February 5, 2019

**ADDENDUM NO. 1**  
**Heber Springs Water and Sewer**  
**HIGH SERVICE PUMP STATION**  
**CWB Project No. 15-054**

SHEET NO.  
10R

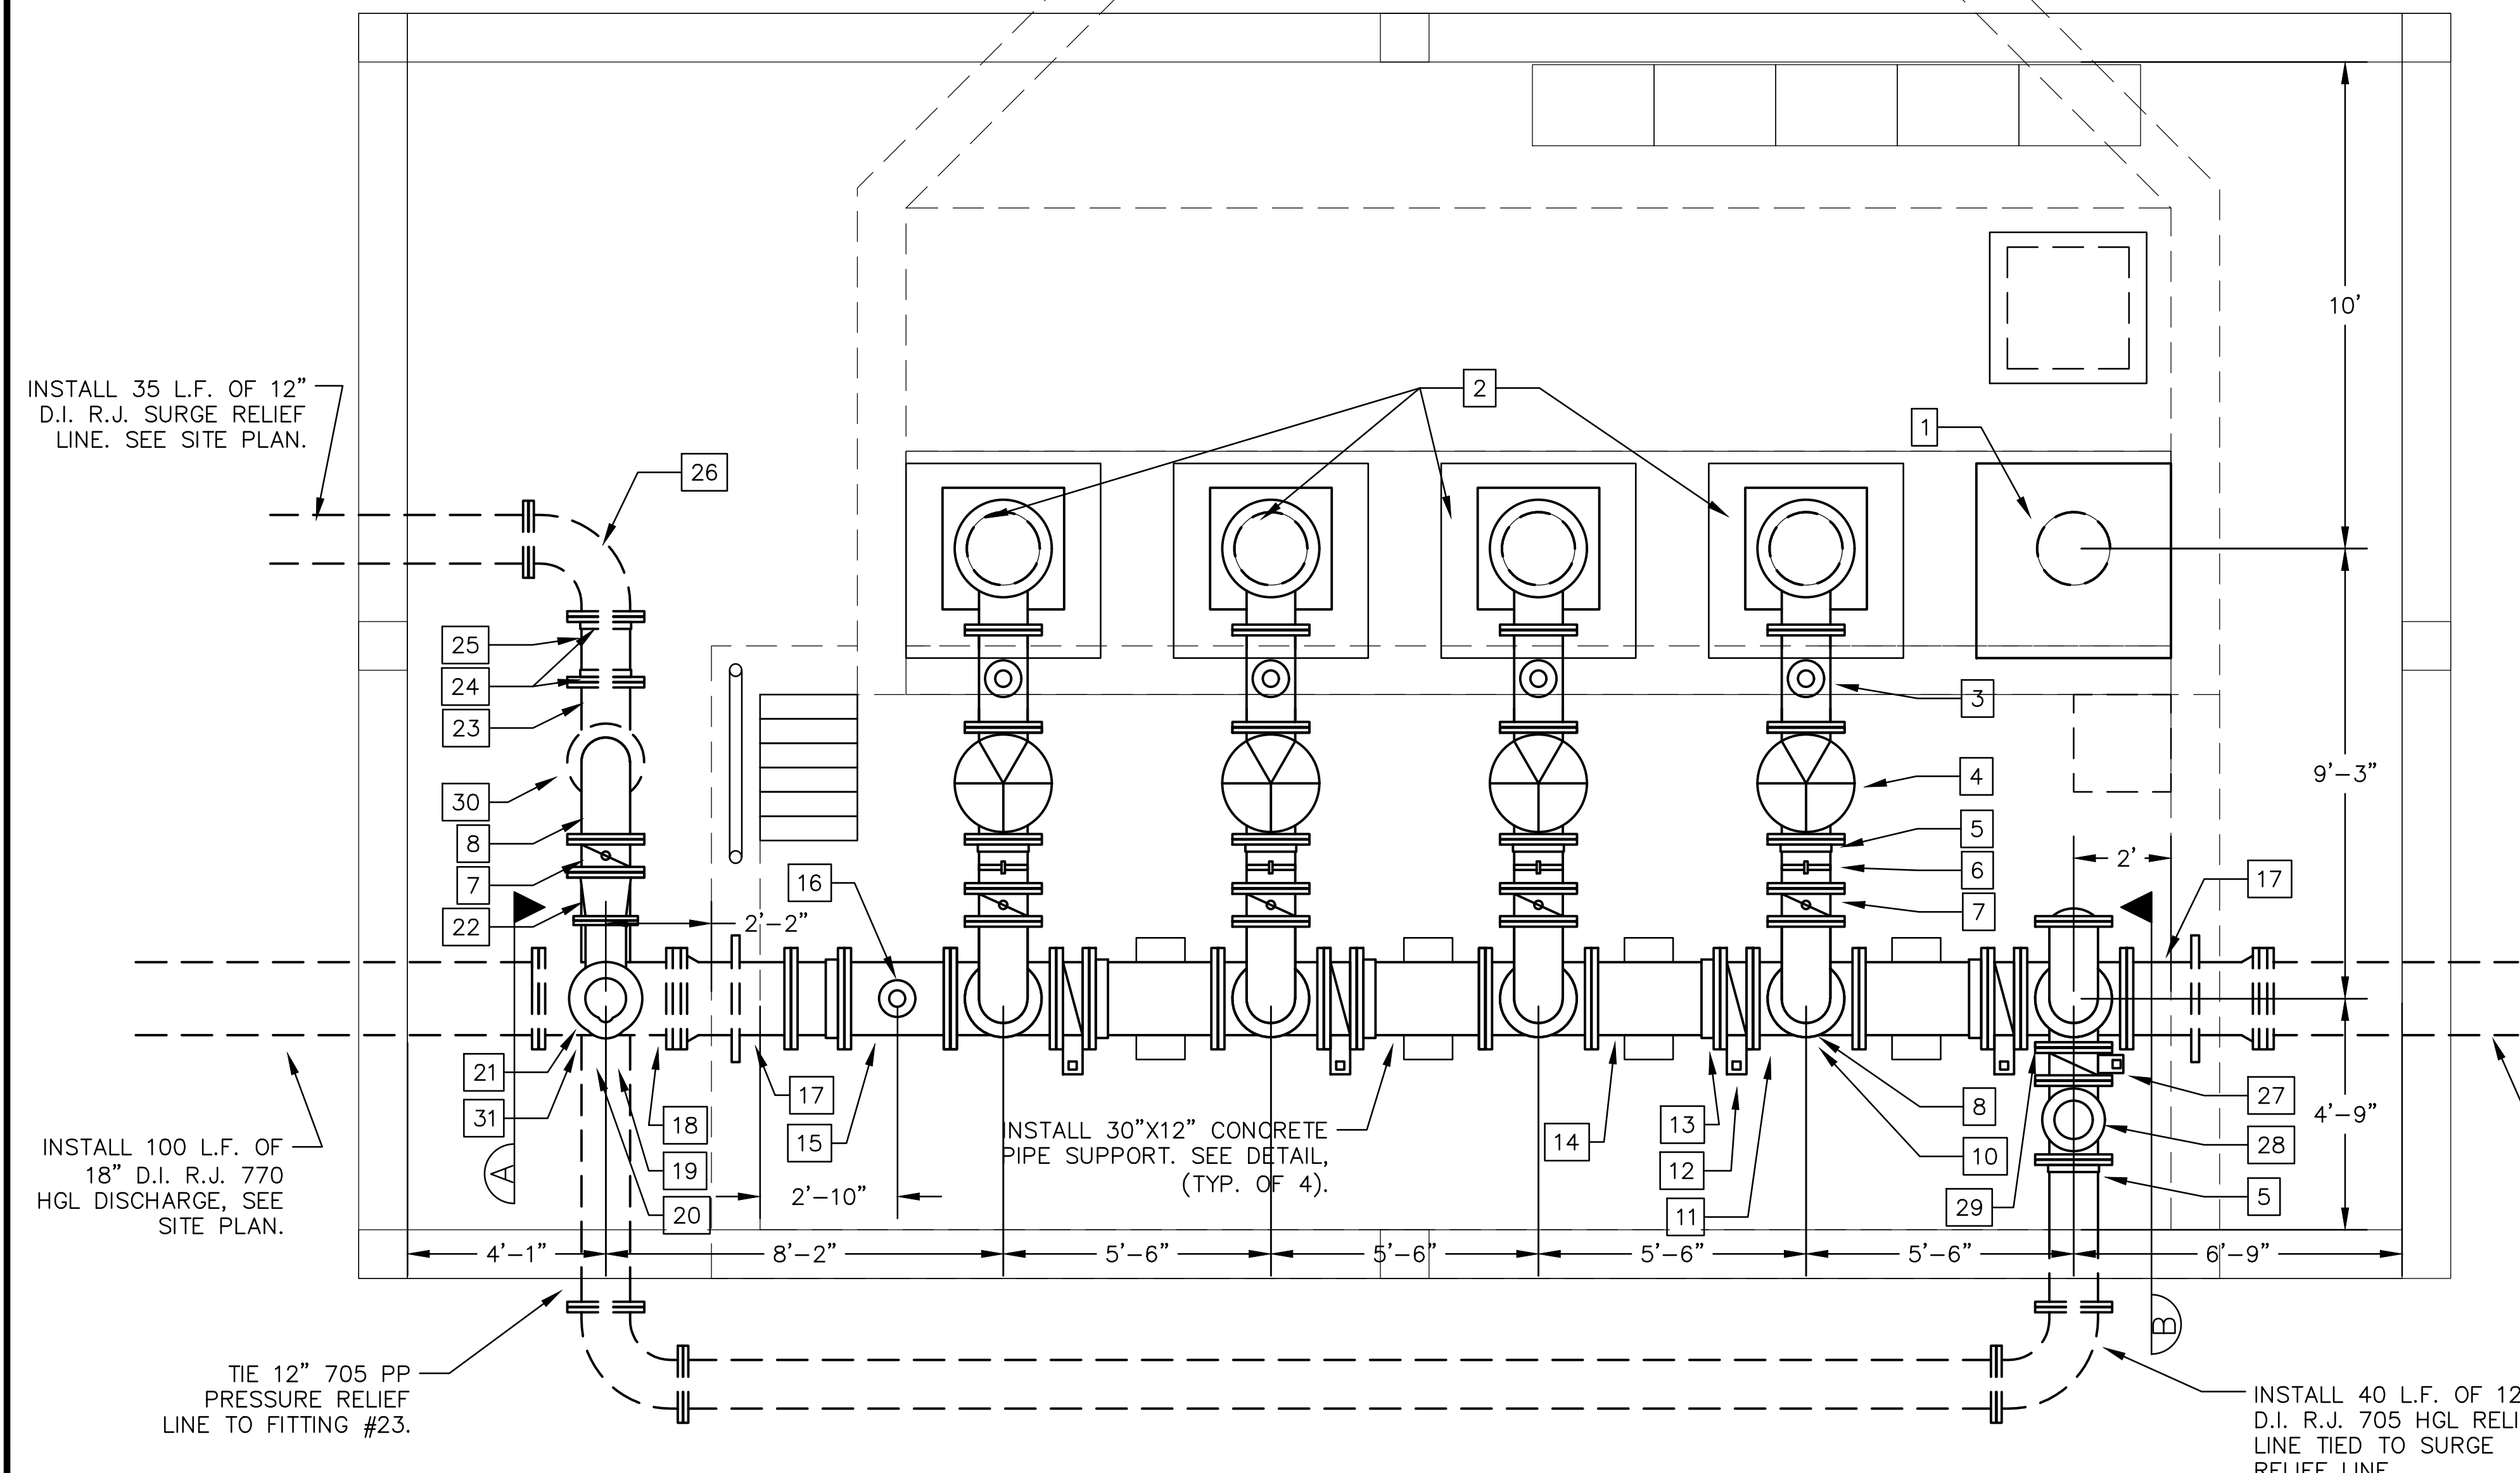
**Replace Sheet 10 in its entirety with the attached ADD#1-Sheet 10R.**

HSPS PIPING PLAN  
RFI DETAILS

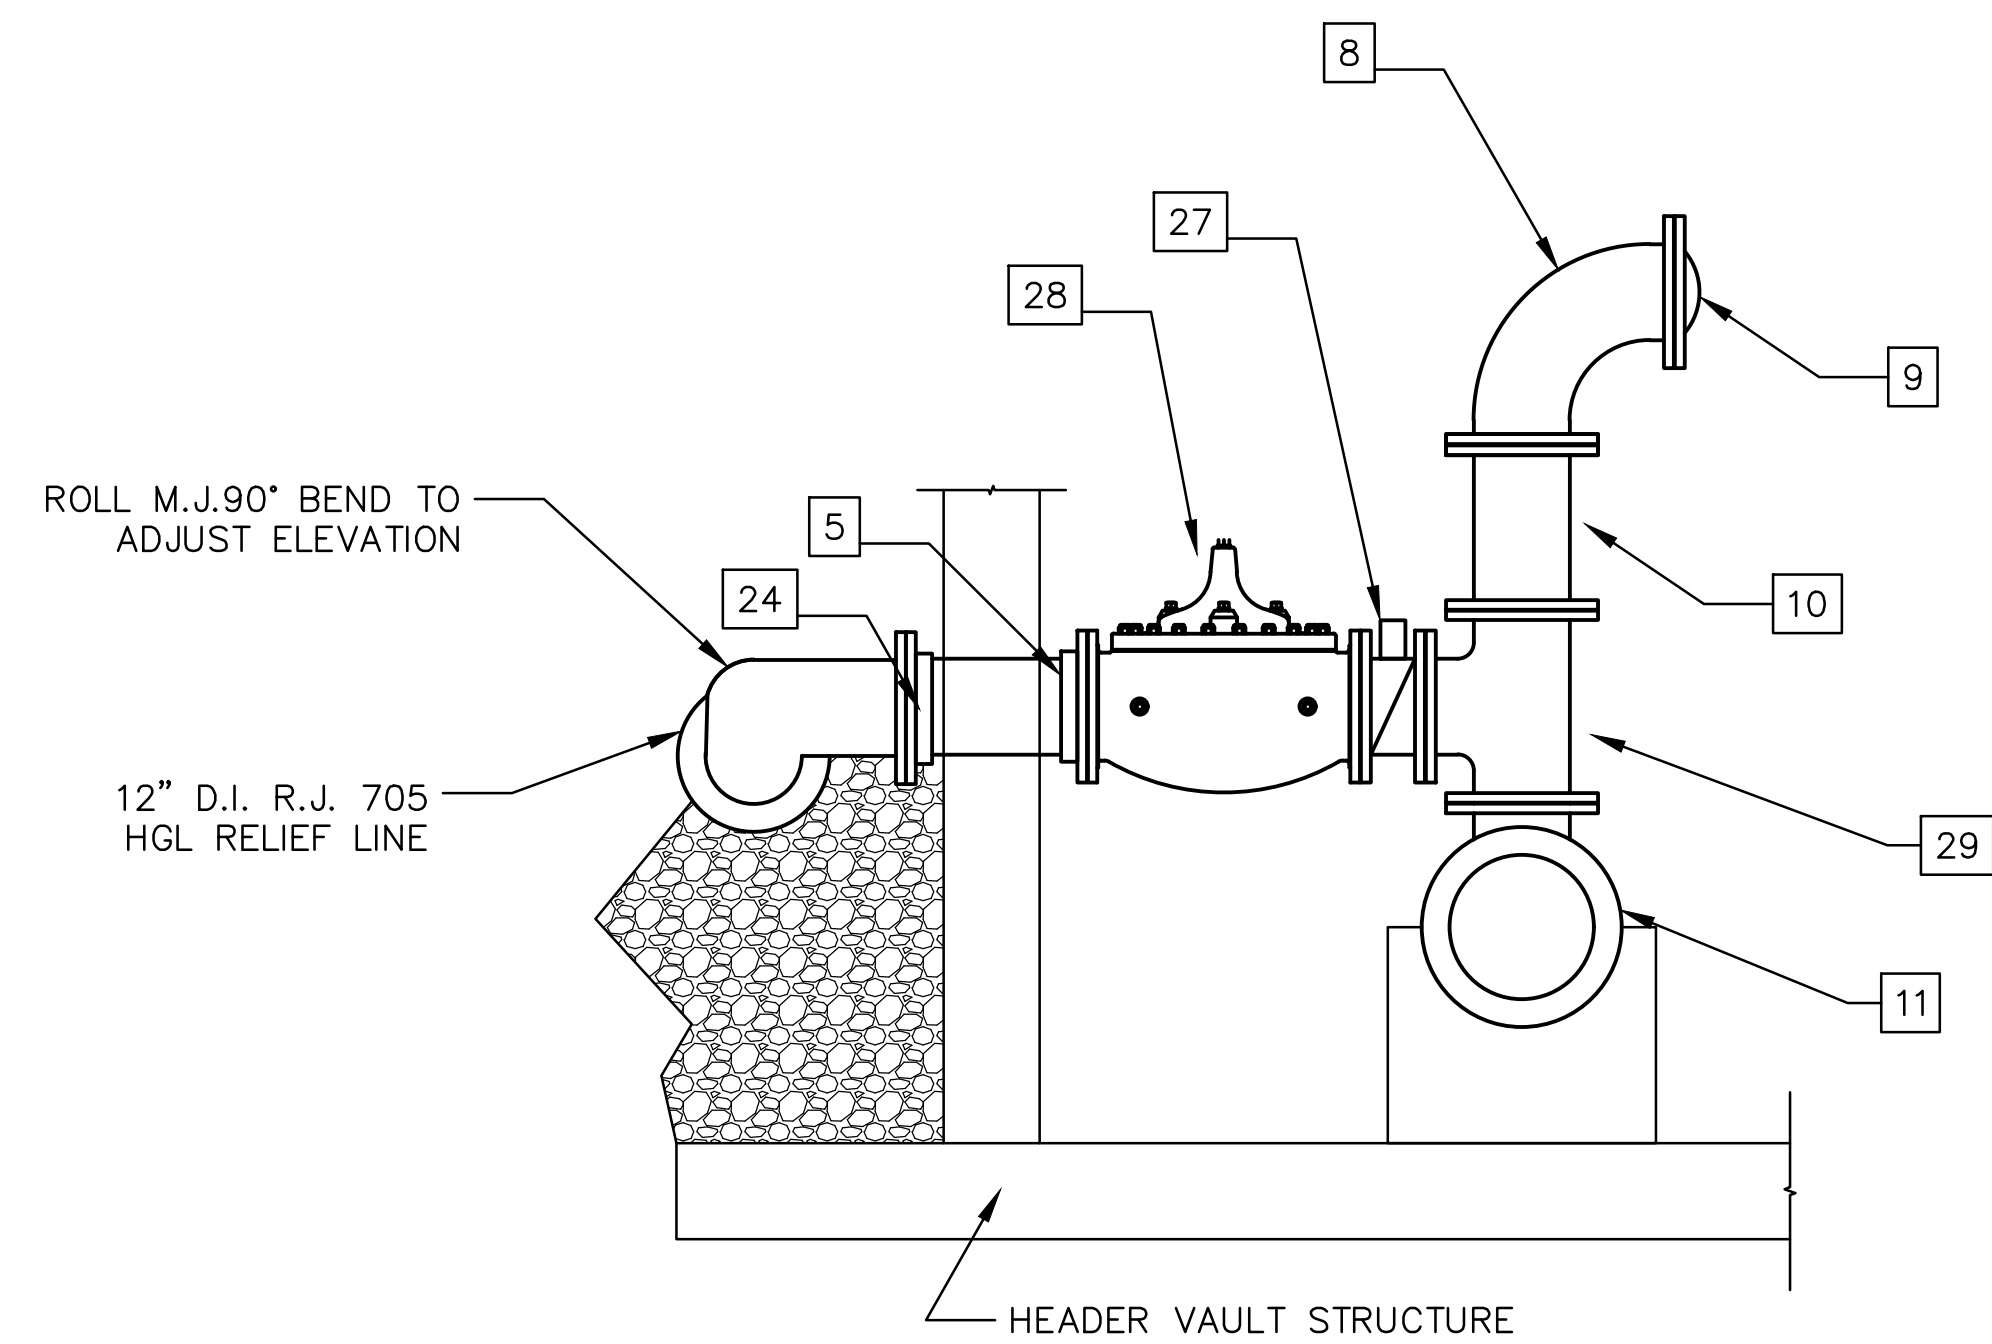
**To clarify the piping layout on Sheet 10, section cuts were added for the surge anticipation and pressure relief valve areas. Please refer to the attached Sheet 10A.**
